Our Ref: 82017208-02:Letter007
Contact: Dean Nealon

16 August 2019

UOW FLOOD TRAINING WALL HYDRAULIC ASSESSMENT - SECTION 4.55(1A) MODIFICATION TO SSD 8569

Flood Risk Precinct Developed (Flood Training Wall)

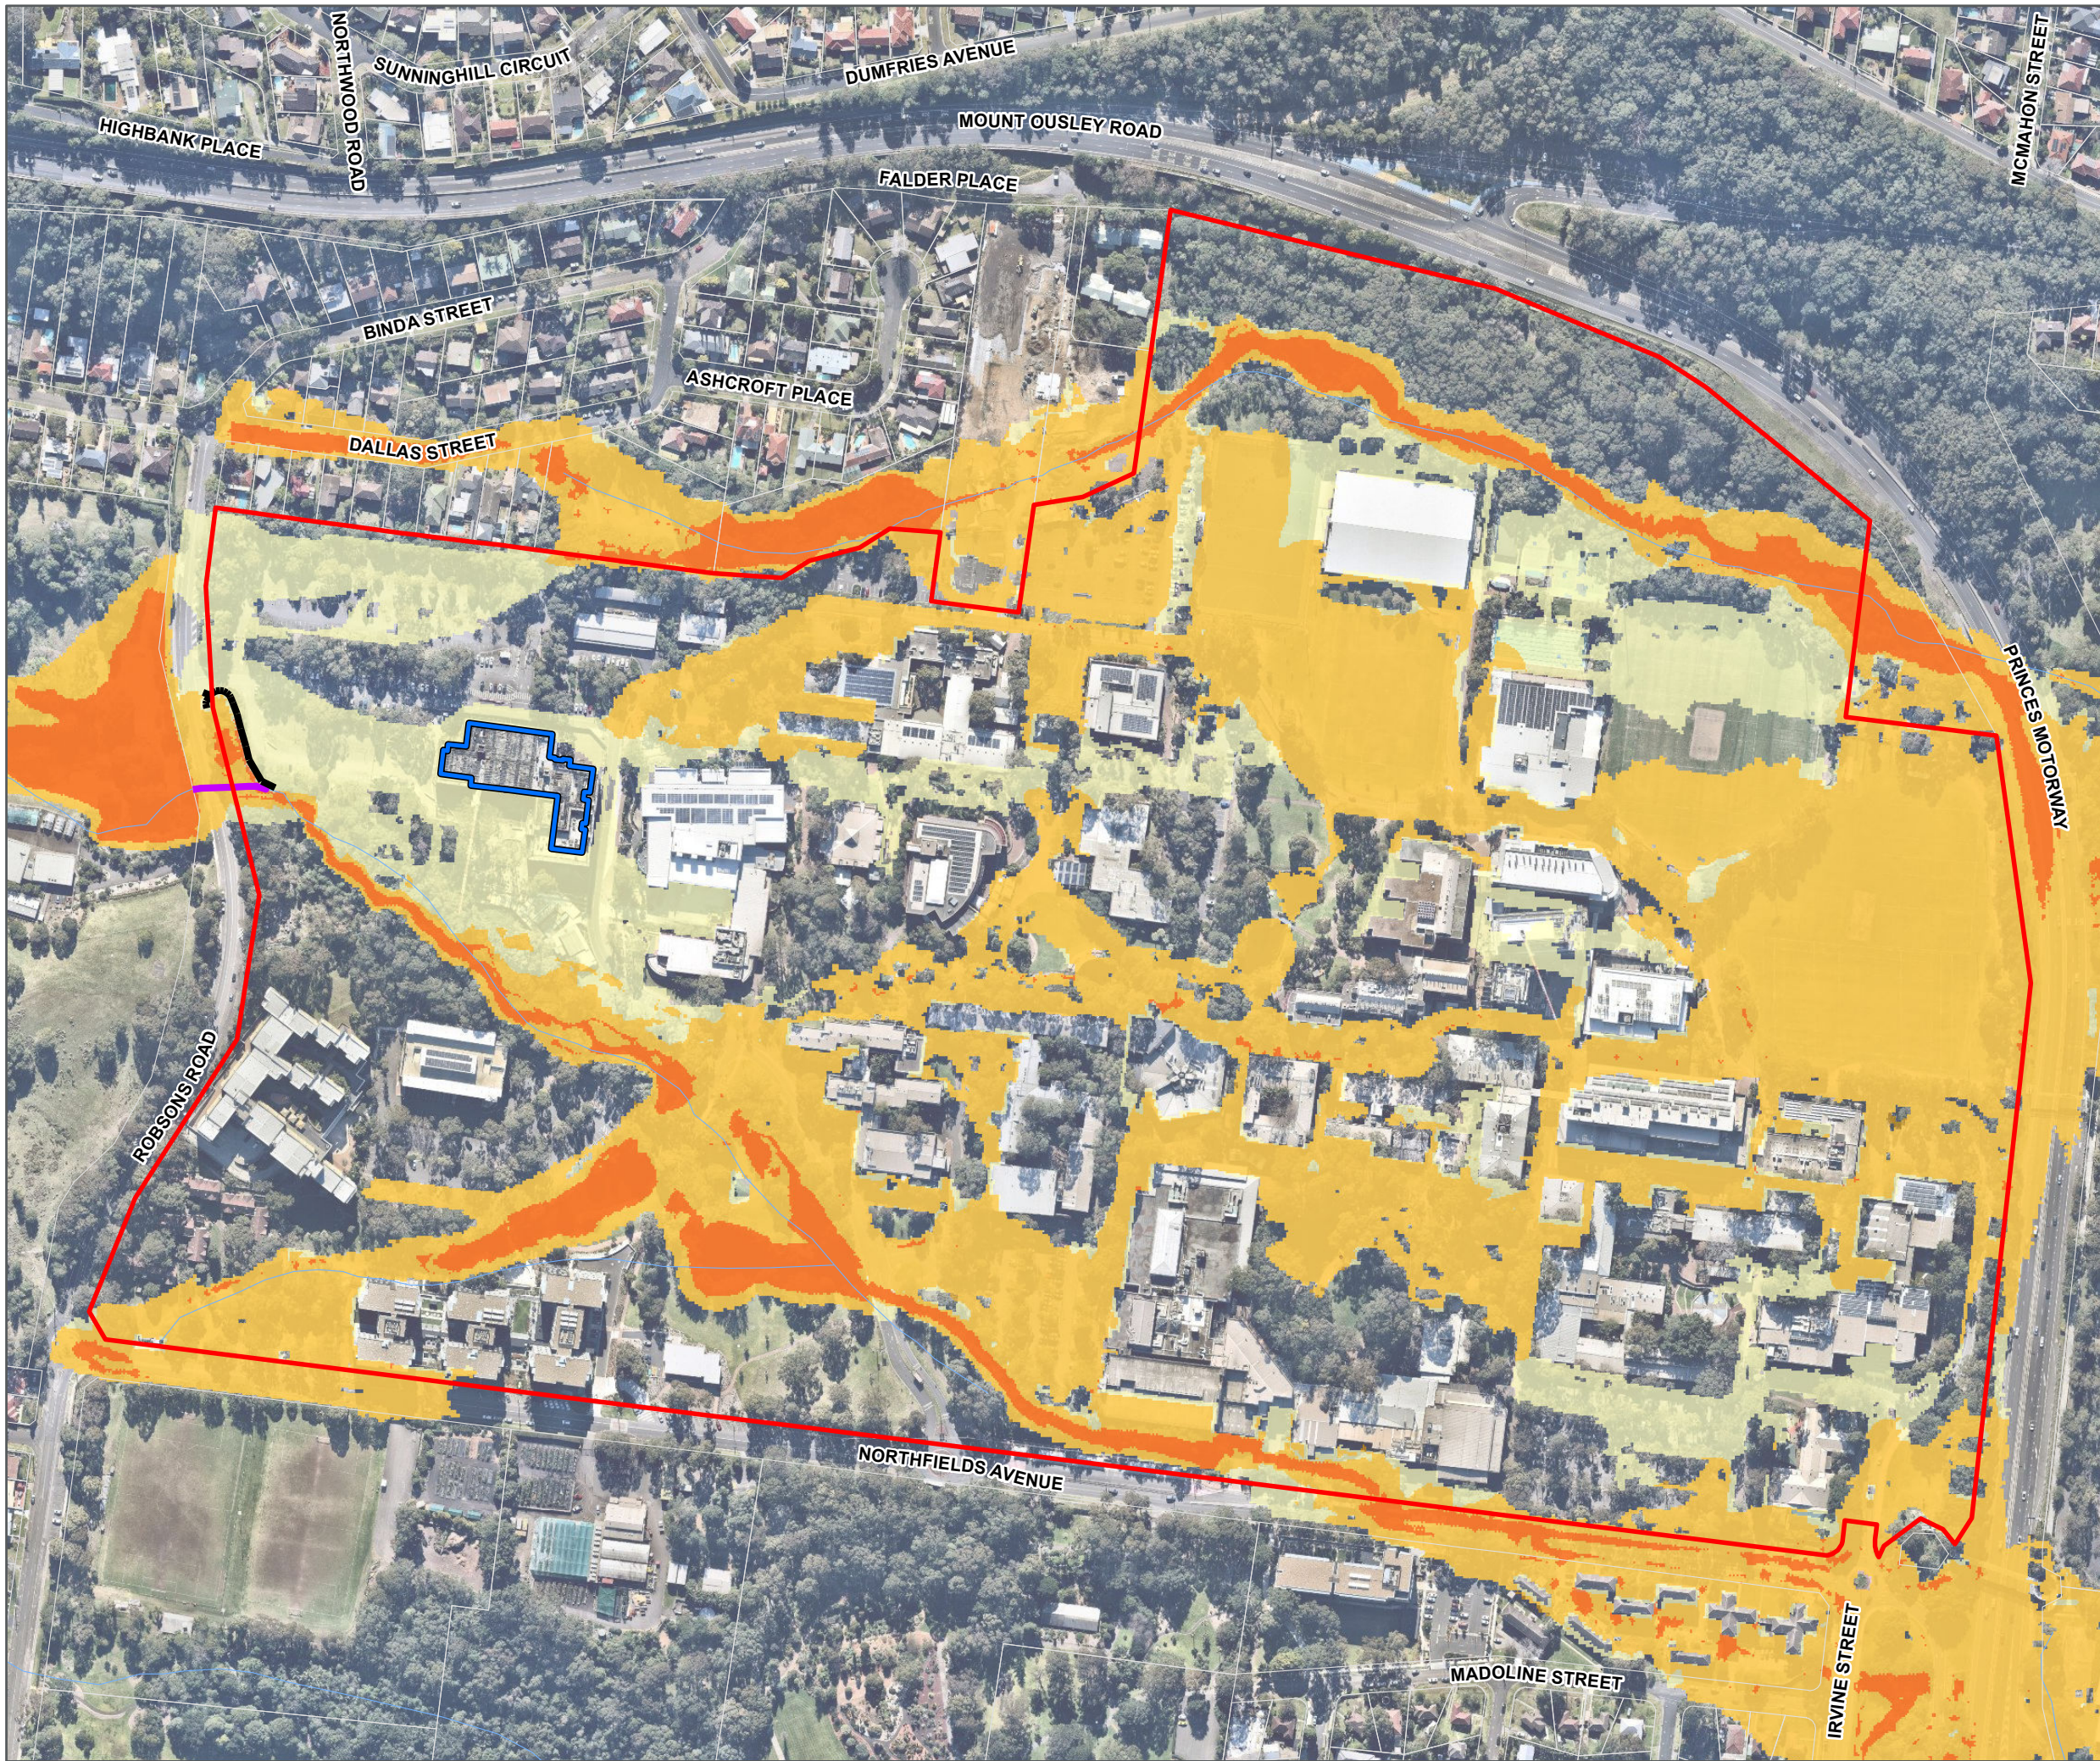
WCC's DCP (2009) - Chapter E13 requires that flood prone land should be divided into three flood risk areas (refer **Table 2-1**) to determine flood planning requirements for proposed development. An updated flood risk precinct map for the flood training wall modification has been enclosed with this letter.

Results demonstrate that the proposed flood training wall is sufficient to remove the ASSB from the medium risk flood precinct and therefore the flood planning requirements for the ASSB are identical to those approve with the initial concept.

Flood Impacts 100 Year ARI (Flood Training Wall)

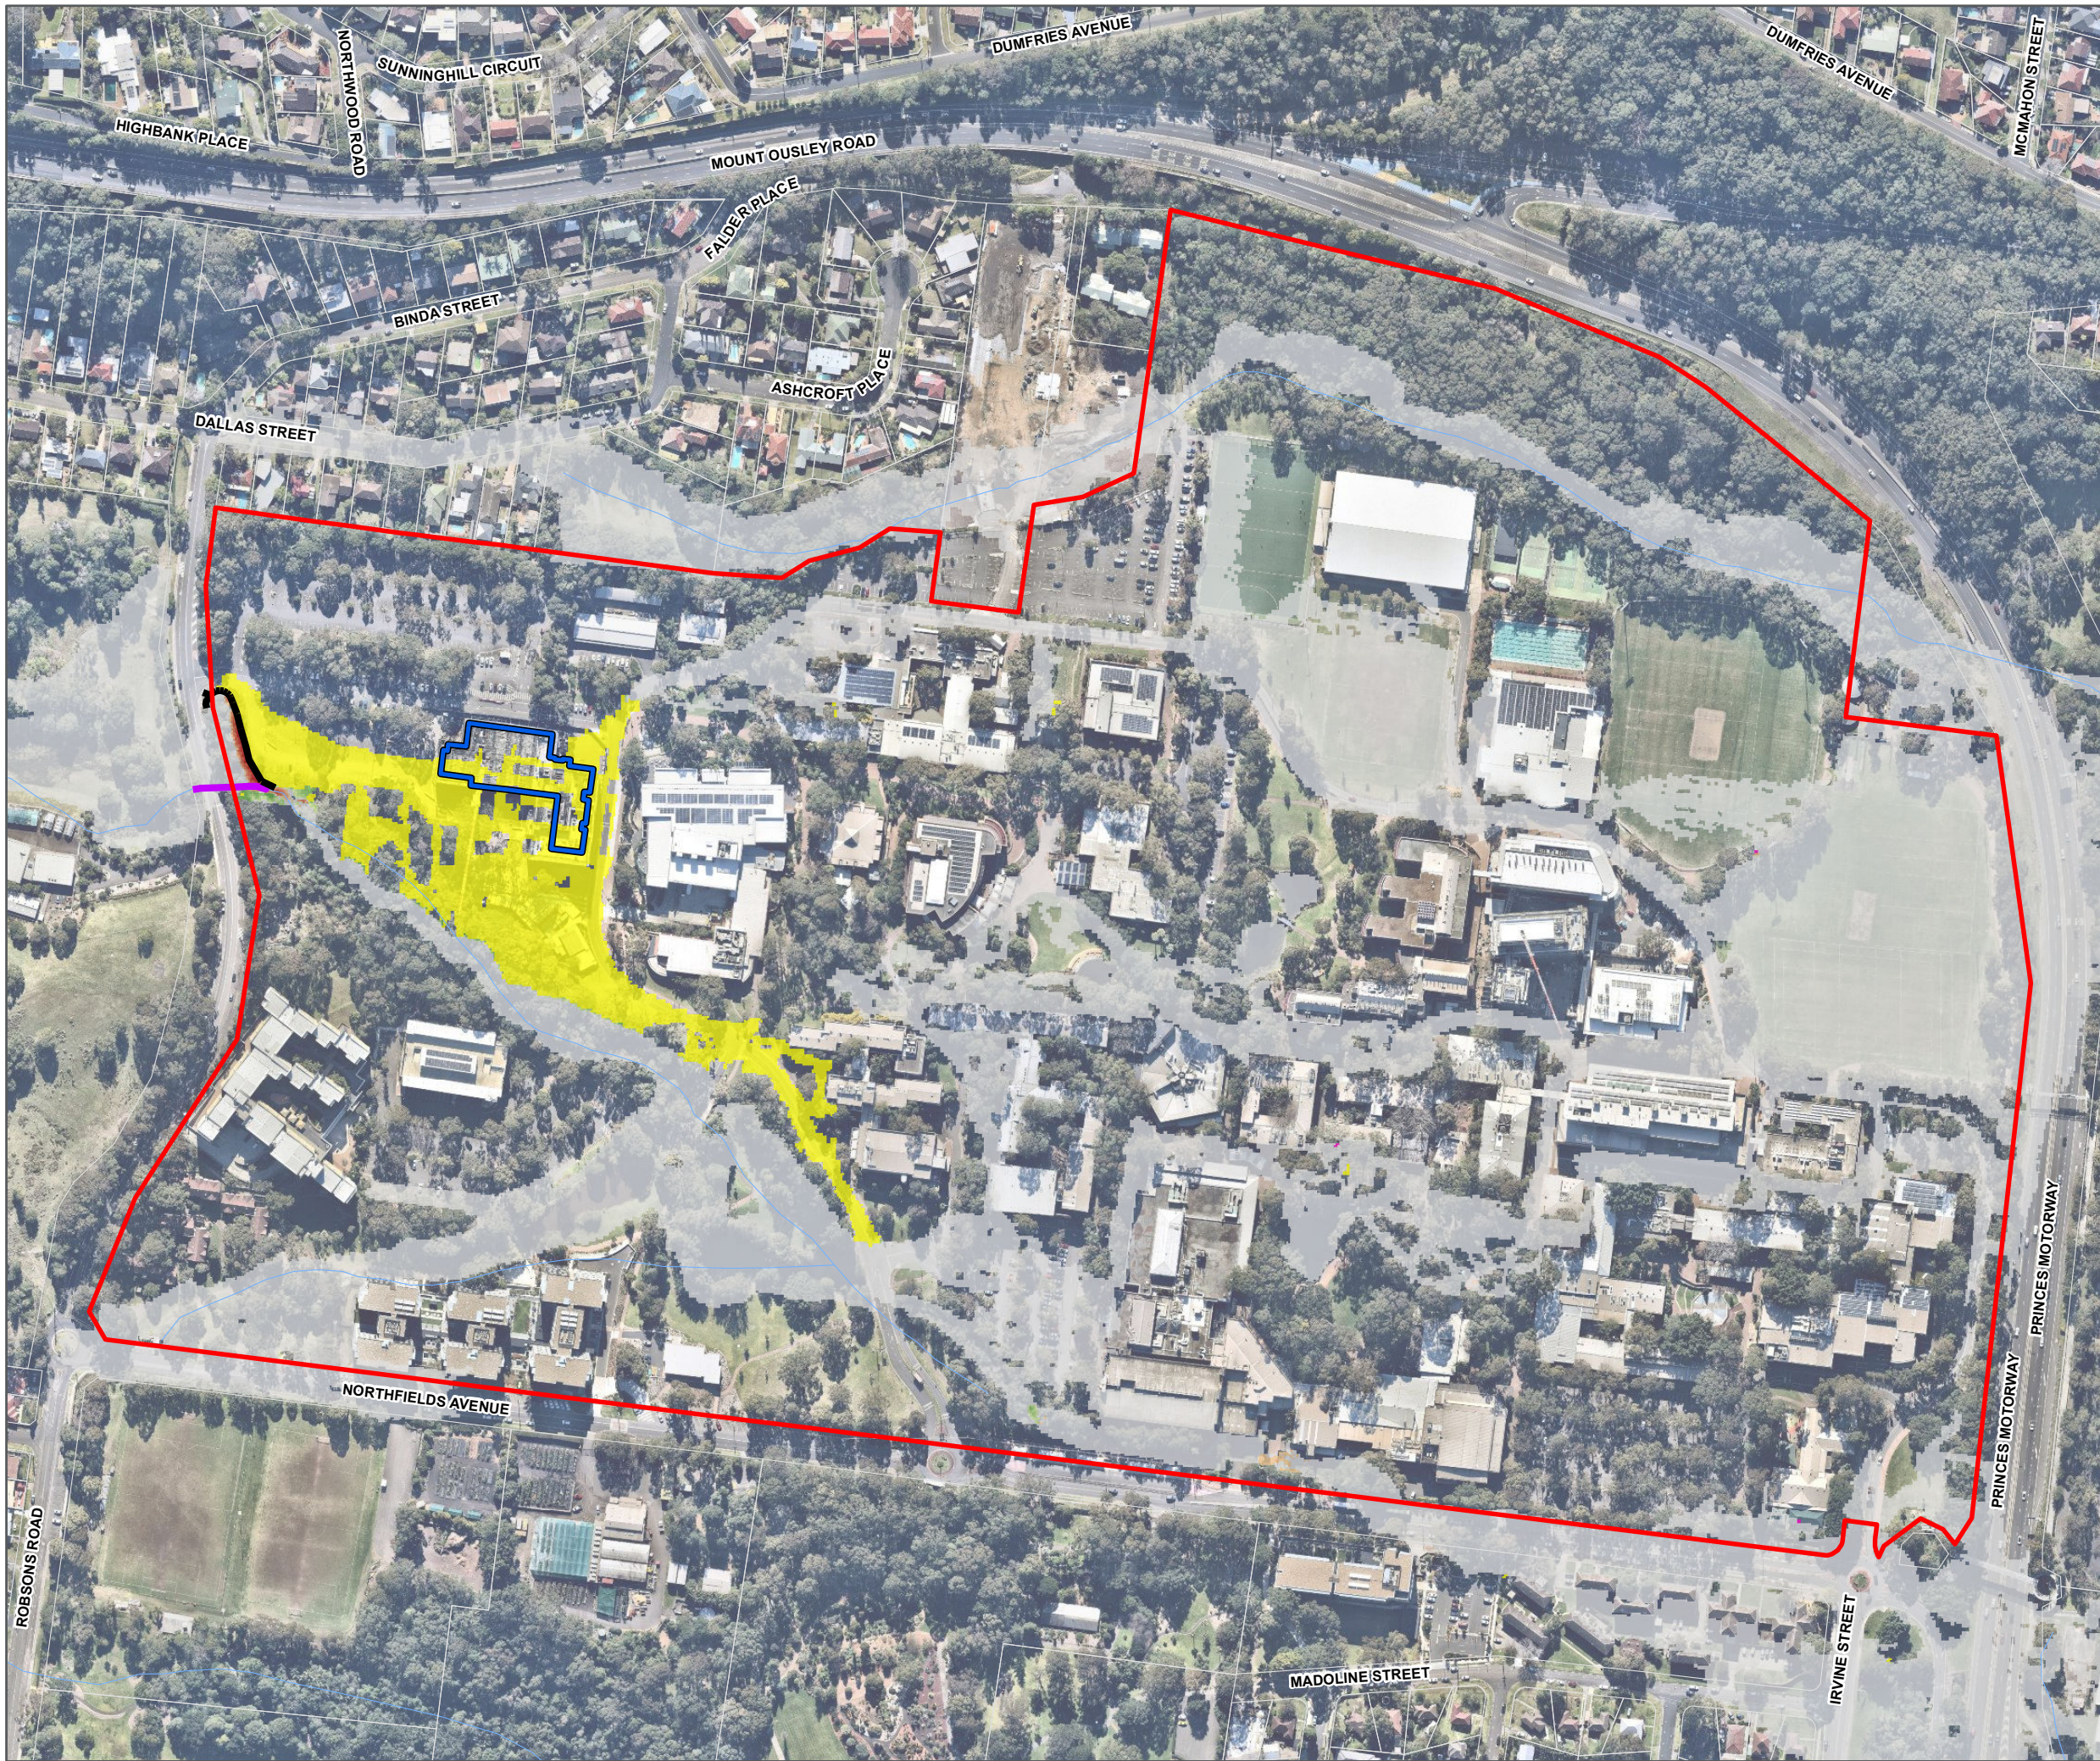
Changes in flood elevations in the 100 year ARI and PMF storm events as a result of the proposed works were assessed and flood impacts maps have been enclosed with this letter.

Results demonstrate no detrimental impacts in the 100 year ARI or PMF Events. In consideration that there are no meaningful effects to floodplain behaviour as the result of the proposed development, it can also be concluded that there are no increase in risk to life or property as a result of this proposal.
